# Seafox Addition

City Plan Commission — August 14, 2025

CASE NUMBER/TYPE:	SUSU25-00066 – Major Final
CASE MANAGER:	Alonso Hernandez, (915) 212-1585, HernandezJA5@elpasotexas.gov
PROPERTY OWNER:	Worldwide, LLC
REPRESENTATIVE:	Robert Steffens, Olsson
LOCATION:	West of U.S. Highway 54 and North of Stan Roberts Sr Ave. (District 4)
PROPERTY AREA:	1,038.9 acres
VESTED RIGHTS STATUS:	Not Vested
PARK FEES:	Not Required
ZONING DISTRICT(S):	C-4 (Commercial)
RELATED APPLICATIONS:	SUSU24-00065 Seafox Addition

# ATTACHMENT 2

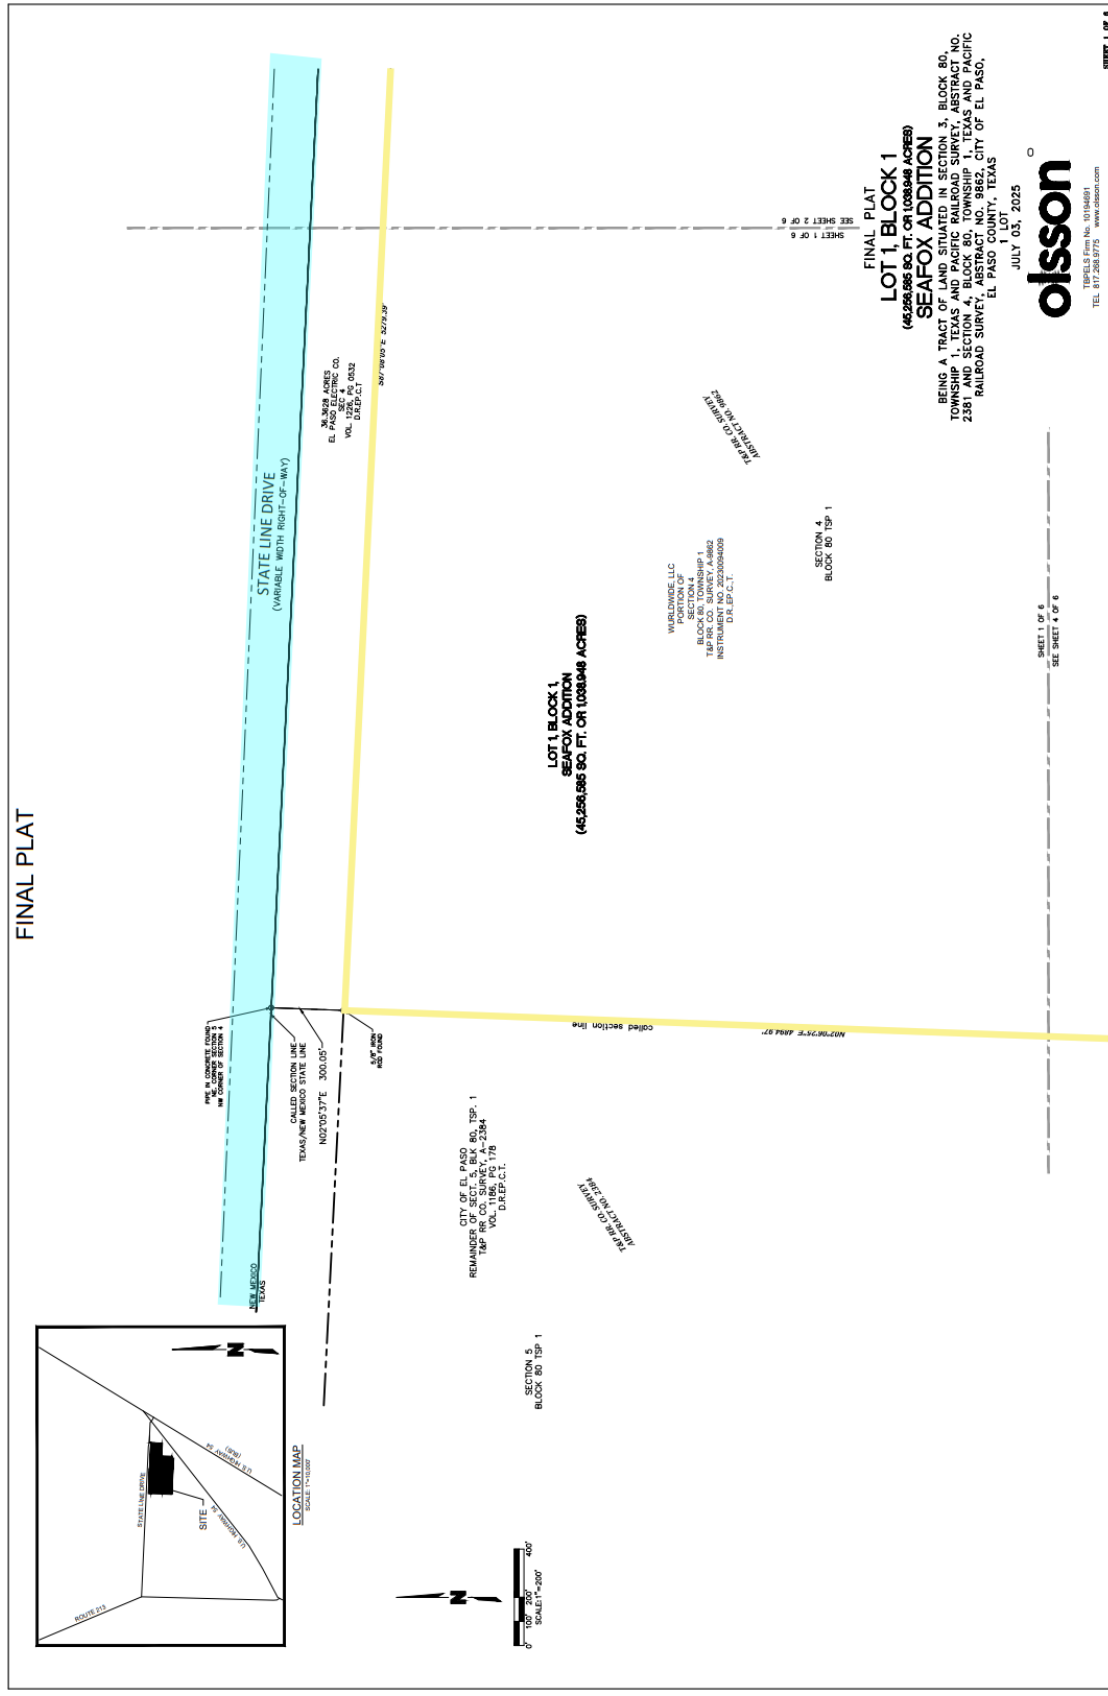
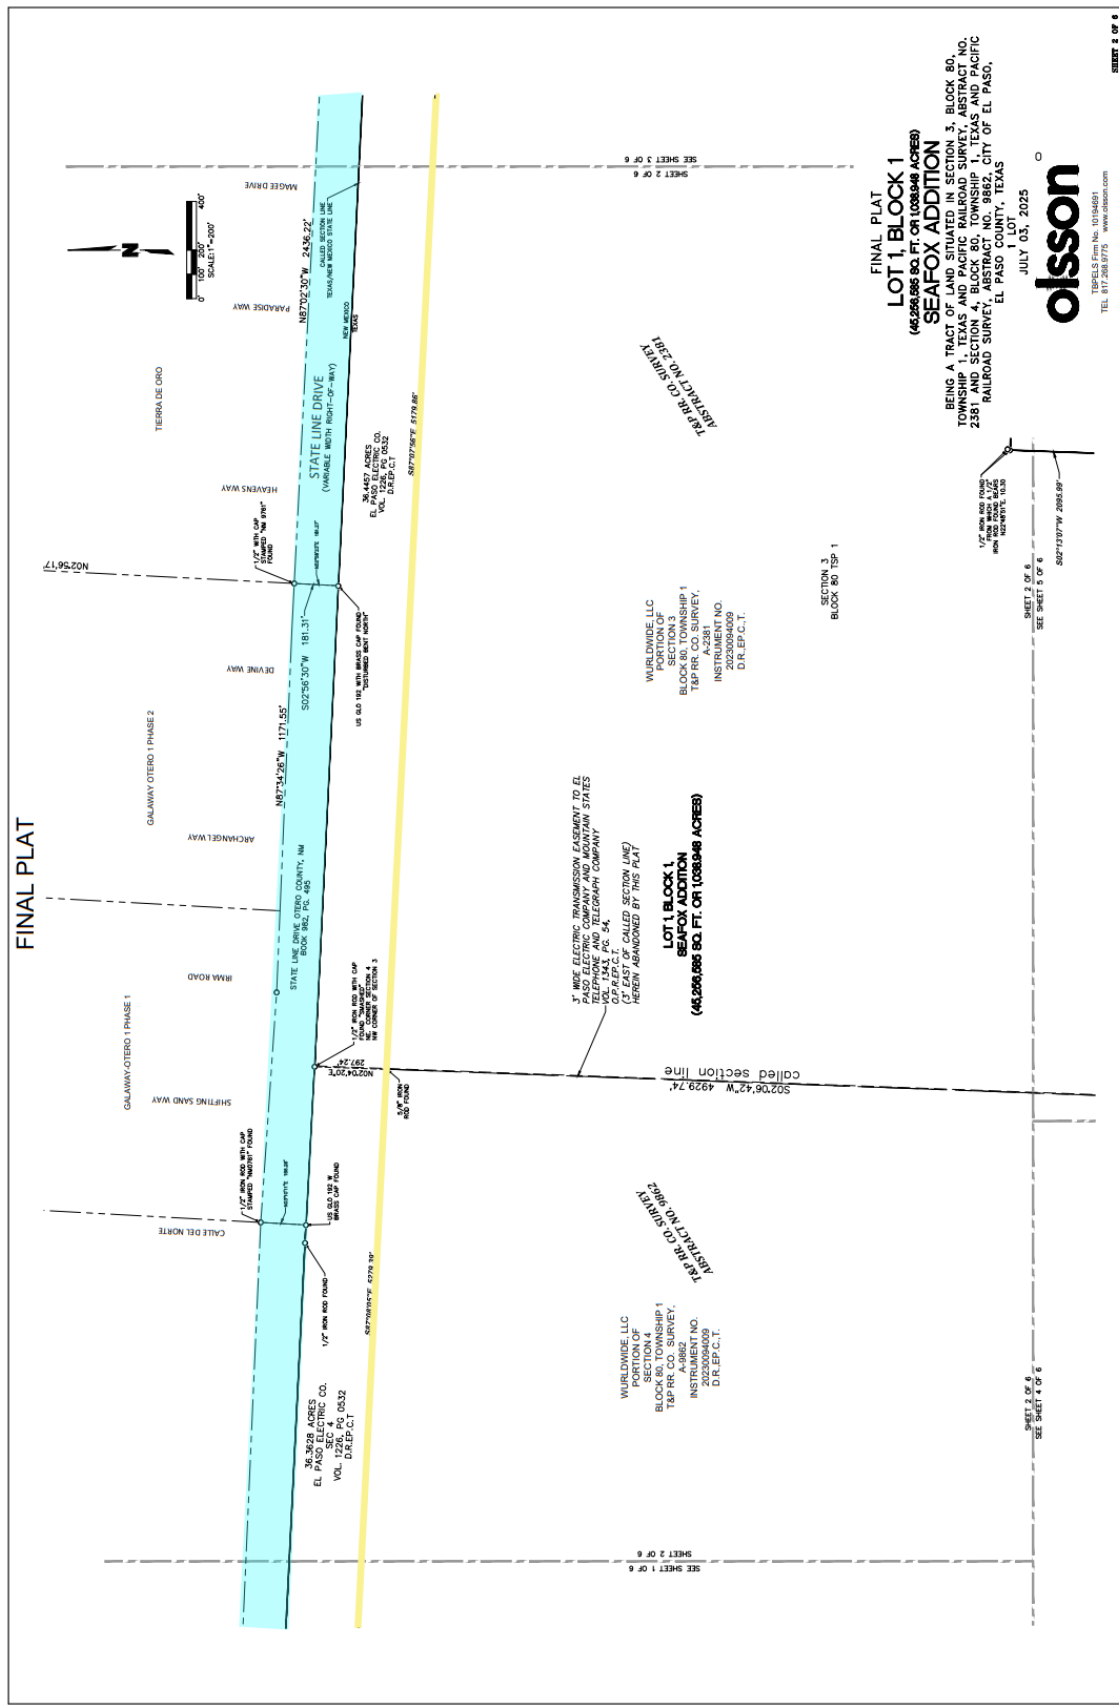
3. Please add the CPC Approval Statement and the corresponding signature lines to the Final Plat.
4. Include the Filing statement on the Final Plat.
5. Provide tax certificate statement on the final plat notes.
6. Include restrictive covenants statement on the final plat notes if applicable. Provided instrument does not correspond to the required covenants.
7. Staff recommends to update provided postal delivery service statement to the following:

8. Provide the adequate school district applicable to the proposed subdivision (Ysleta)
9. Please ensure that the subdivision name is in boldface type, no smaller than one-half inch in height, so that it stands out for easy identification.

10. Provide name and width of abutting rights-of-way on the Final Plat.
11. Provide address or proposed address for the lot on Final Plat.
12. Staff recommends including an Overall Plan that shows the full parcel subdivided into the sections presented on each sheet (1–5), for easier and clearer identification.

13. Please double-check the 'Preliminary' note on Sheet 6 of 6. If it is not necessary , remove it.
14. Include a location map on each sheet that indicates the specific part of the parcel represented on the plat.

1. On the preliminary plat, provide the direction of flow of all watercourses, location, type, material and size of any existing and proposed storm water drainage structures and/or facilities.

2. **Submit the complete public improvement plans for the Stan Roberts Ave. under SIPS24-00015 in order to review.**
3. Provide print-out of the mathematical closure of the exterior boundary of the subdivision indicating the error of closure - (Provide bearings and distance for the complete exterior lot).

4. Fully dimension the easements by bearing and distance or provide a document book and page recording reference numbers, including El Paso Electric Co. easement along Stan Robert Ave.

5. **Provide header curb instead of curb and gutter along proposed Stan Robert Ave. (onsite ponding area).**
6. The subdivision shall be tied to a horizontal control by bearing and distance to either a section corner, survey line, the National Geodetic Survey monument, City monument or other known and accepted survey points. This tie shall be delineated on the plats.

7. Provide and label note on the plat: "If lots are further subdivided, then additional private easement shall be required".
8. Verify "480214IND0A" on Flood zone determination note 10.

9. Provide official address for the Lot 1, Block 1.

Location/Vicinity map shall show Stan Roberts Sr. Ave. (F.M. road 2529) and McCombs St.

On Plans sheet 4 of 6 and 5 of 6 clarify if section of Stan Roberts Sr. Ave. is part of F.M. road 2529.
